Town of Hilton Head Island
Regular Design Review Board Meeting
Tuesday, March 27, 2018 – 1:15 p.m.
Benjamin M. Racusin Council Chambers
AGENDA

STARBUCKS

Project Name: Starbucks @ Sea Turtle Marketplace (Former Pineland Station) Redevelopment

DESIGN TEAM/DRB COMMENT SHEET

2 NORTH ELEVATION
SCALE 1/8" : 1'-0"

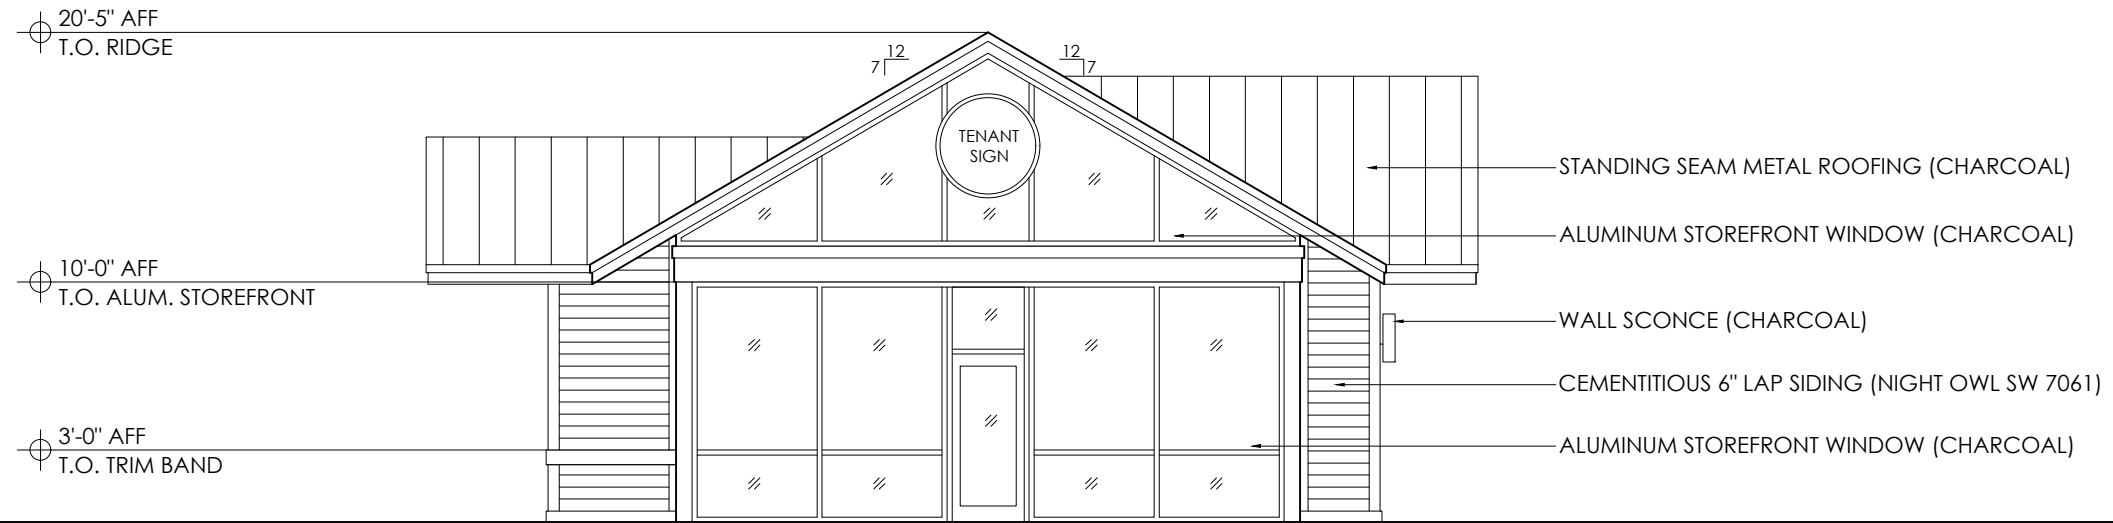
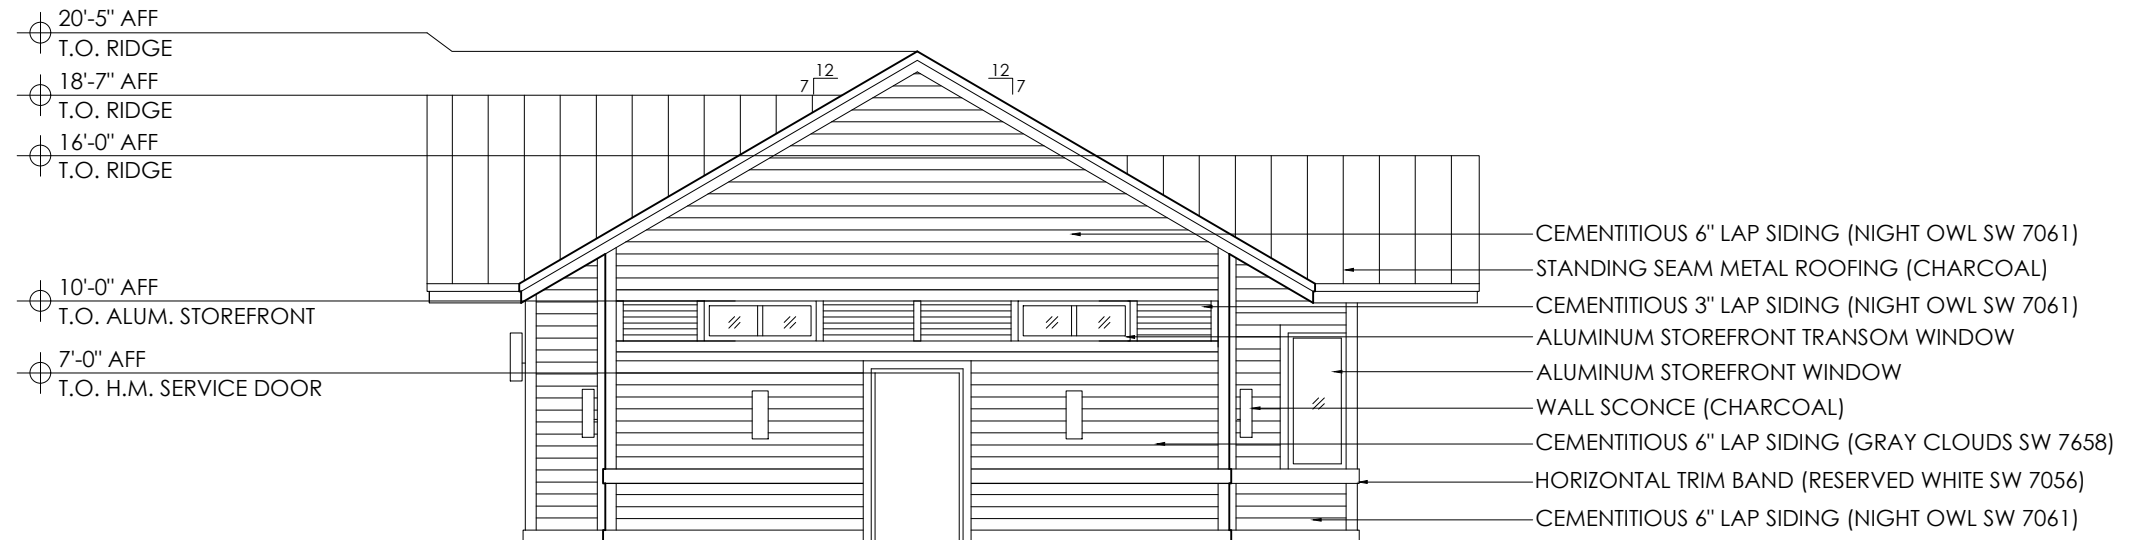
1. Reconsider the clearstory windows or trim to better break up the walls.
2. Reconsider sconce locations and numbers.
3. Reconsider use of Shell Ginger and Philodendron infavor of a species that is more in-keeping with “Island Character”.
4. Provide more room between the 26” Live Oak and the curb and eliminate the planting near the trunk.

DATE
03-13-2018
PROJECT NUMBER
01-17036
SHEET TITLE
SITE PLAN

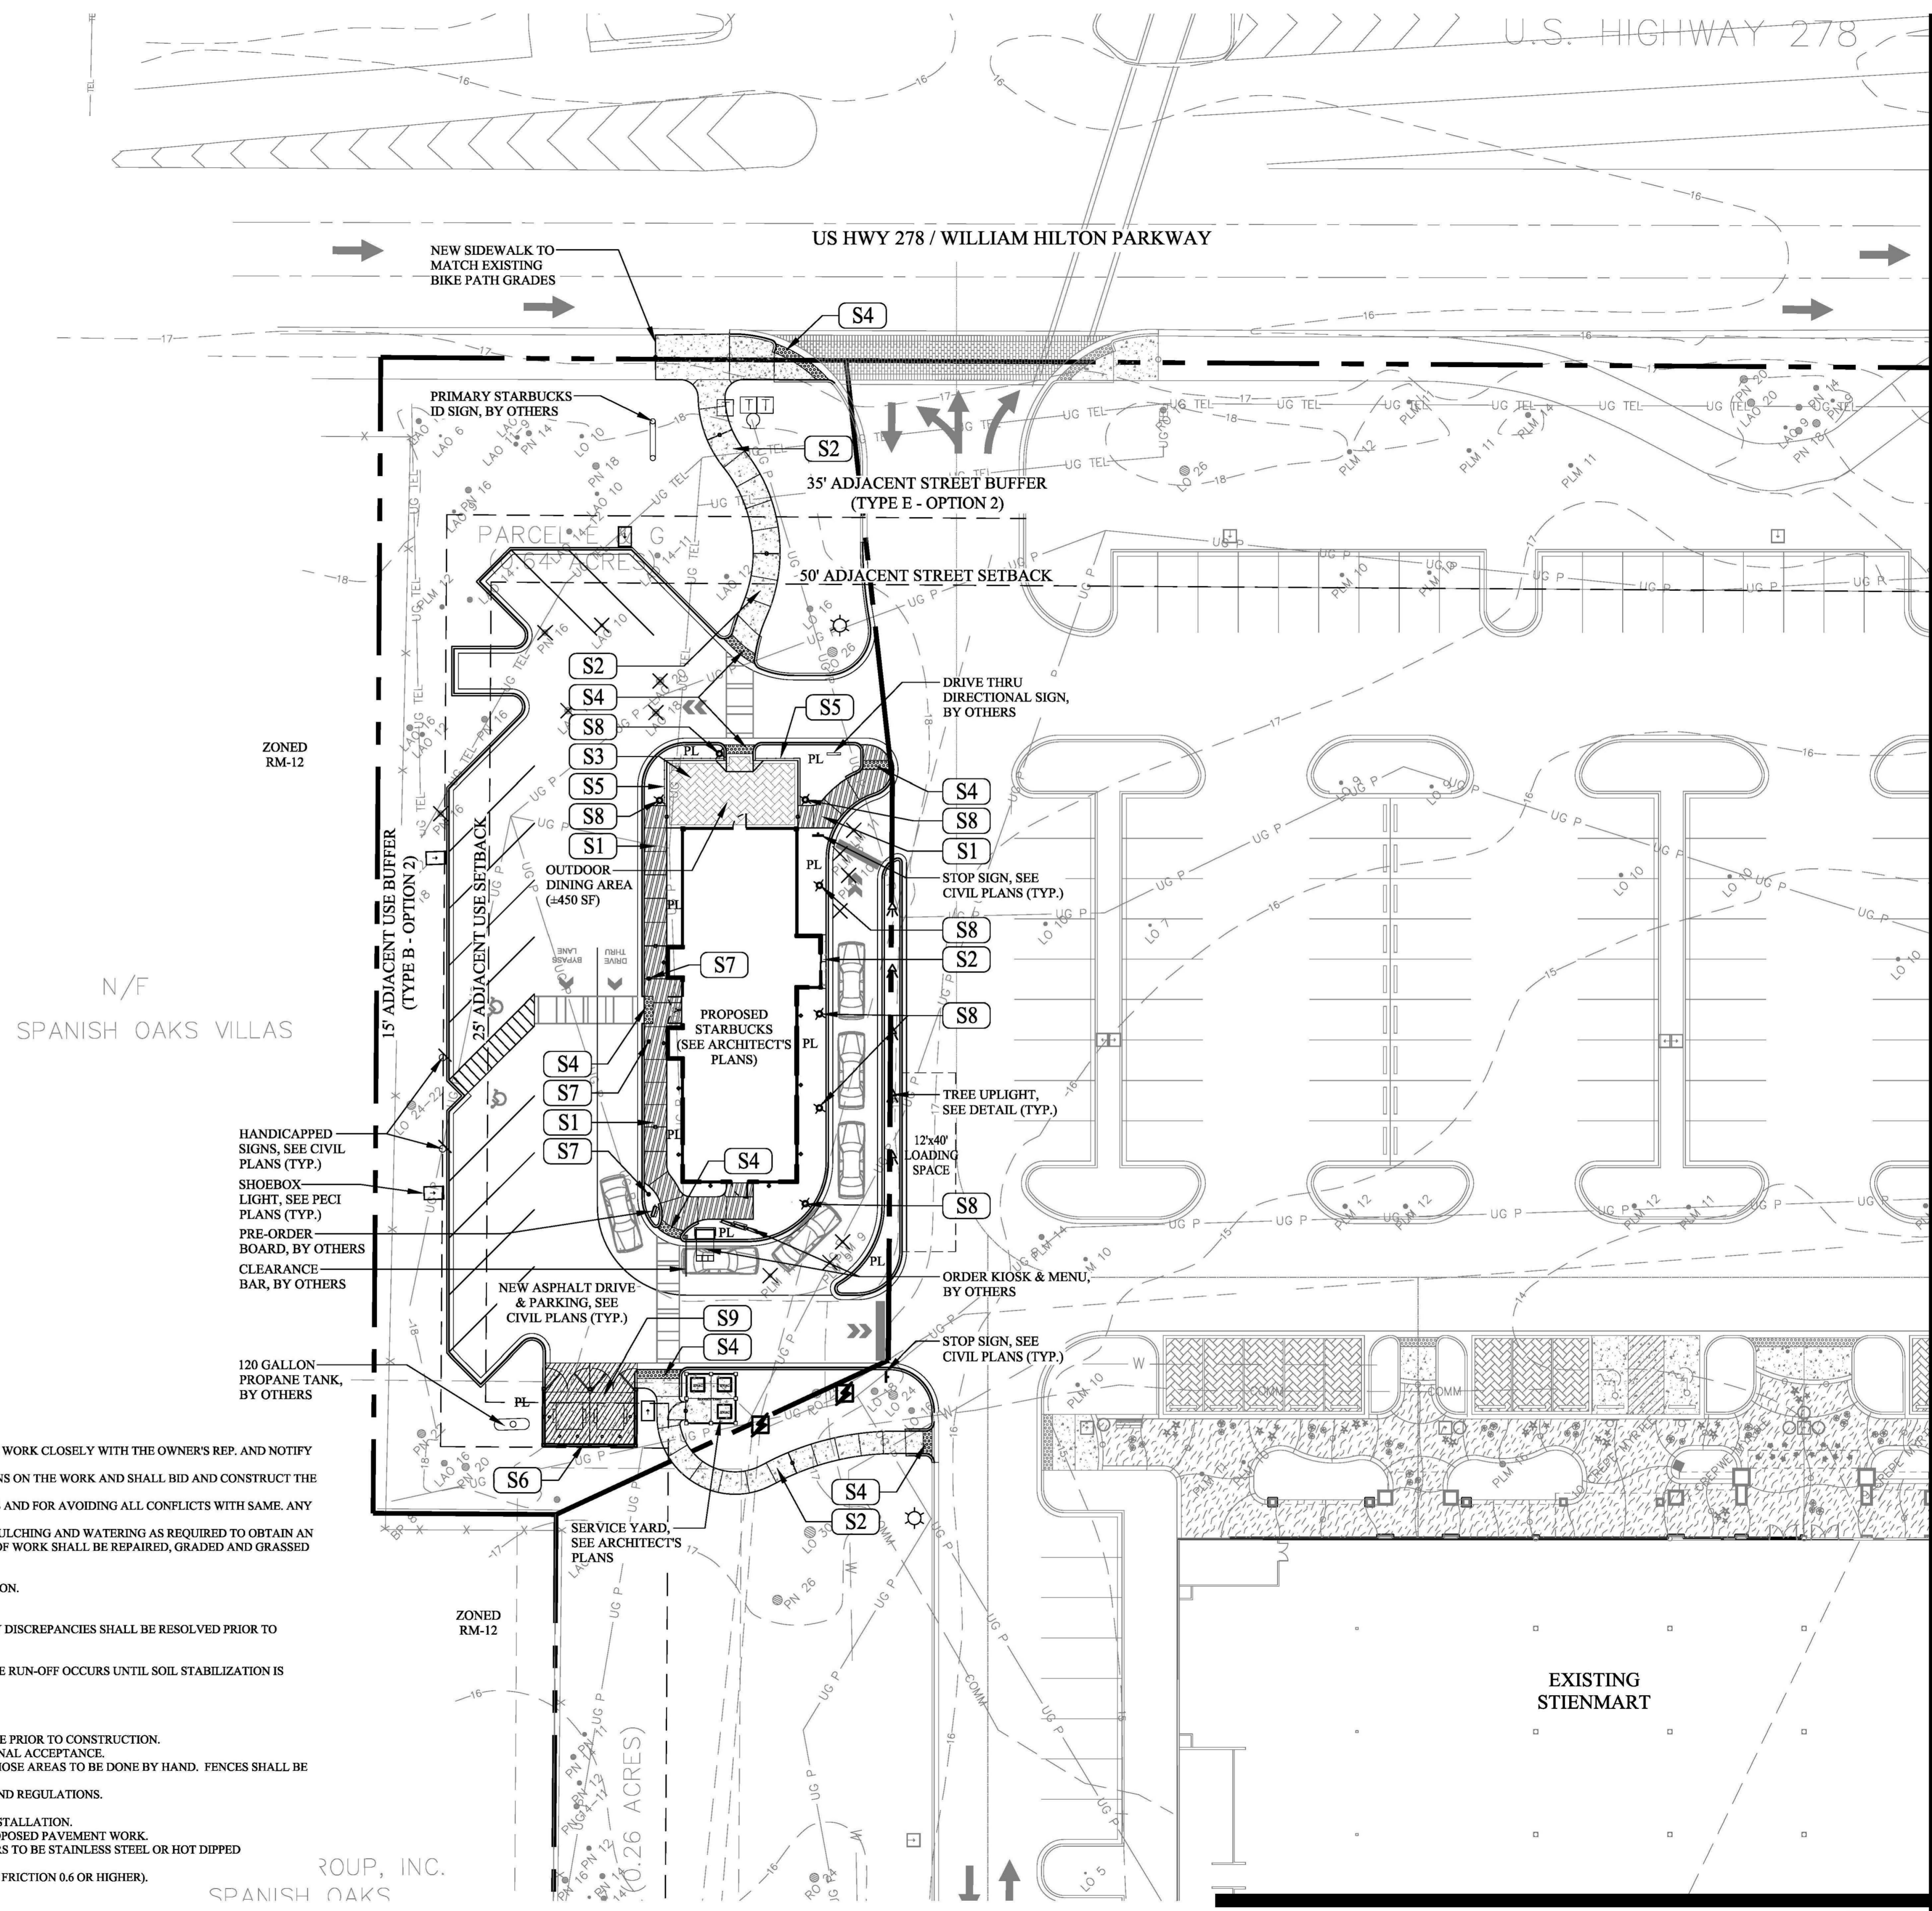
1. Façade signs cannot be above the eve of the roof.
2. Please identify the LP symbol on the plans. Is this and existing light pole and is it to remain?

DATE
03-13-2018
PROJECT NUMBER
01-17036
SHEET TITLE
PLANTING PLAN

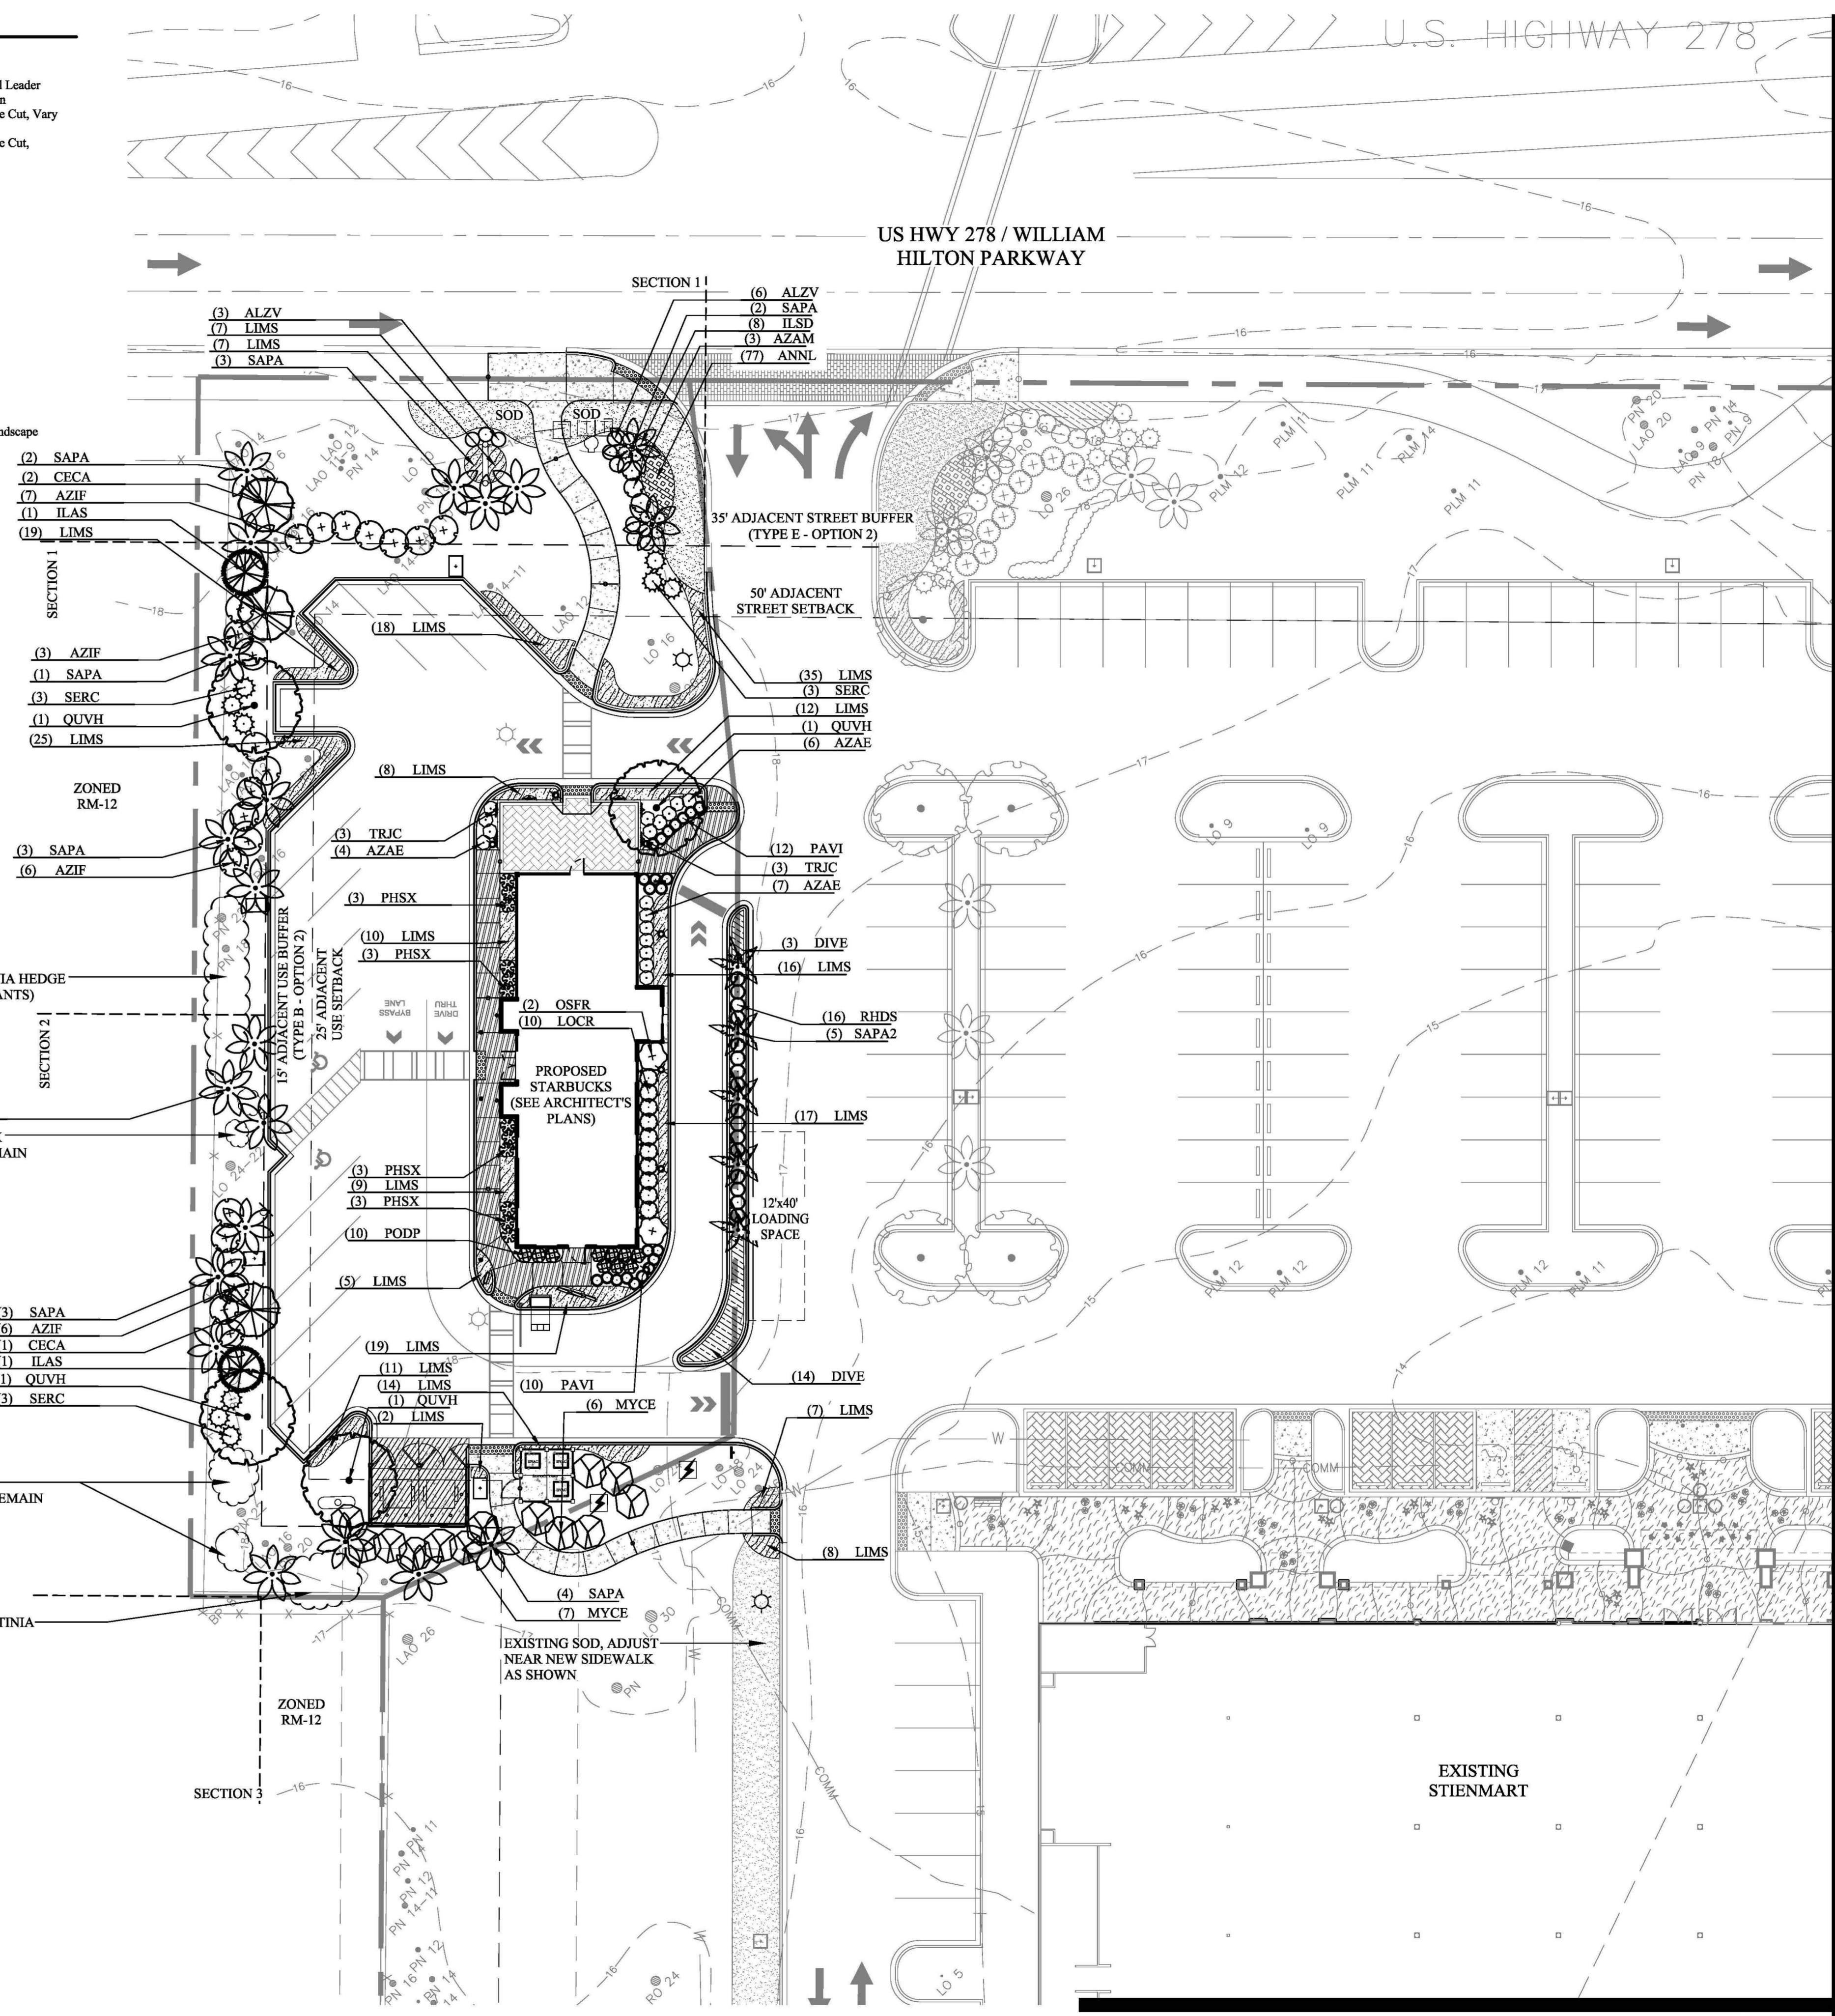
DESIGN GUIDE/LMO CRITERIA	Complies Yes	No	Not Applicable	Comments or Conditions
Preserves a variety of existing native trees and shrubs	<input type="checkbox"/>	<input type="checkbox"/>	<input type="checkbox"/>	
Shrubs are selected to complement the natural setting, provide visual interest and screen less desirable elements of the project	<input type="checkbox"/>	<input checked="" type="checkbox"/>	<input type="checkbox"/>	Shell Ginger and Philodendron do not complement the natural setting.
Native plants or plants that have historically been	<input type="checkbox"/>	<input checked="" type="checkbox"/>	<input type="checkbox"/>	Consider finding a substitute for Shell Ginger and

prevalent on the Island are utilized				Philodendron that is more in keeping with "Island Character".
The location of existing mature trees is taken into account in placement of shrubs so as not to damage tree roots	<input type="checkbox"/>	<input checked="" type="checkbox"/>	<input type="checkbox"/>	Delete the lirioppe from around the 26 Live Oak on the Hwy 278 side of the building. Reduce the depth of the patio, eliminate the planting between the patio and the drive isle, eliminate the planting between the building and the walk at the back of the building (moving the building back). Maybe all of the above.

DESIGN GUIDE/LMO CRITERIA	Complies Yes	No	Not Applicable	Comments or Conditions
An effort has been made to preserve existing trees and under story plants	<input type="checkbox"/>	<input checked="" type="checkbox"/>	<input type="checkbox"/>	There needs to be more room between the 26" Live Oak and the curb to make it viable.
